Site Selection and Alternative Sites Assessment

SLD Wiltshire Ltd – Written Representation Submission

The Applicant's Ranking of Potential Development Areas

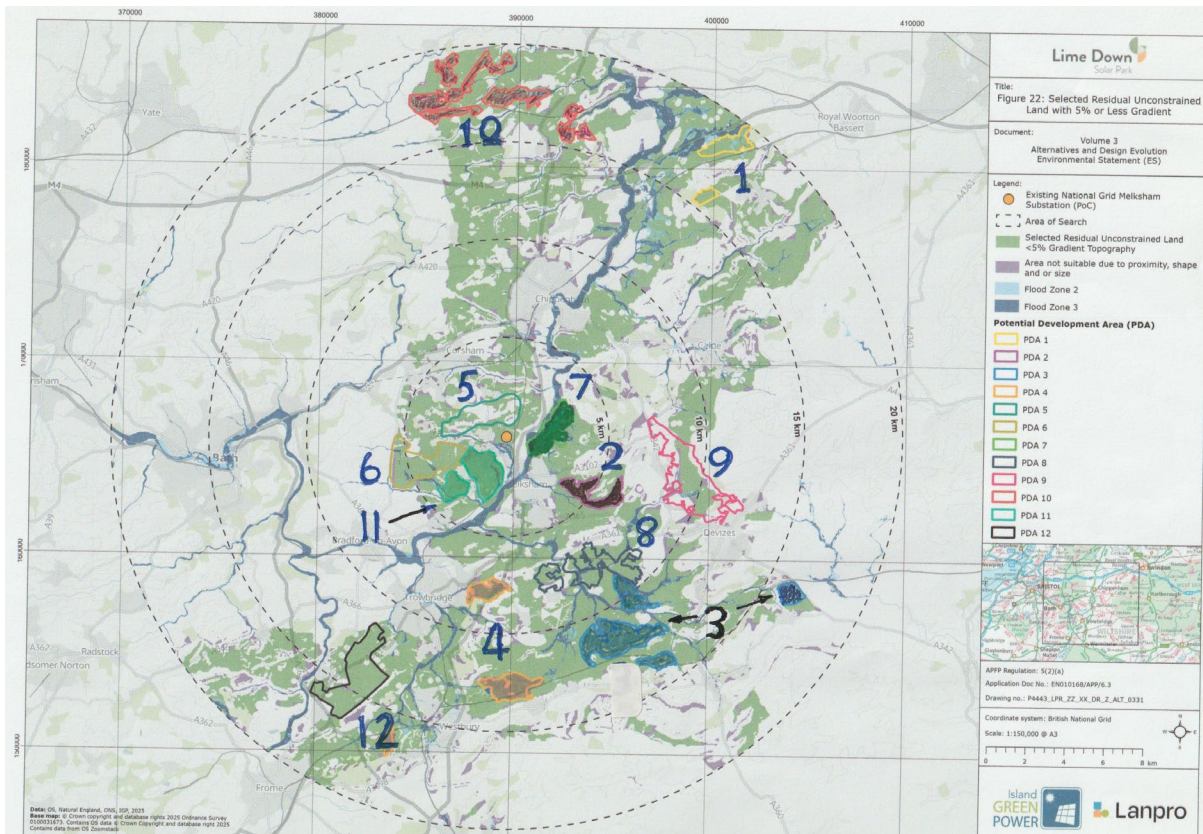
37. SLD and its consultants have reviewed the RAG (red-amber-green) evaluation contained in Annex D to the SSAR. SLD’s reassessment results in the following adjustments:

Topic	PDA 10 (Lime Down)	Comments
Ecology and Diversity	No change (amber)	
Landscape and Visual	Downgrade from amber to red	As SLD identify, there are obvious and significant harms arising out of the proximity of the proposed development to the Cotswolds National Landscape. It is doubtful how such positioning can properly meet the requirements of “avoidance”, or be properly seen to comply with s.85 CROW 2000. The National Landscape skirts the site to both the north and west. Despite the alterations the Applicant has made in response to the CNLB’s objections, solar infrastructure would still be readily

38. Two important things result from this reanalysis. The first is that, properly considered, a number of reds are identified for PDA 10, making it the least desirable site. The second is that, comparing a weighted analysis of the Applicant’s conclusions (Appendix B) to a weighted analysis conducted appropriately by SLD (Appendix C), it is apparent that PDA 10 measures as the most constrained. On either basis, and applying the Applicant’s own approach to selection based on these outcomes, PDA 10 was and is not appropriate for this development. It is for that reason that there are such significant negative effects of the proposed development addressed through the remainder of SLD’s Written Representation.
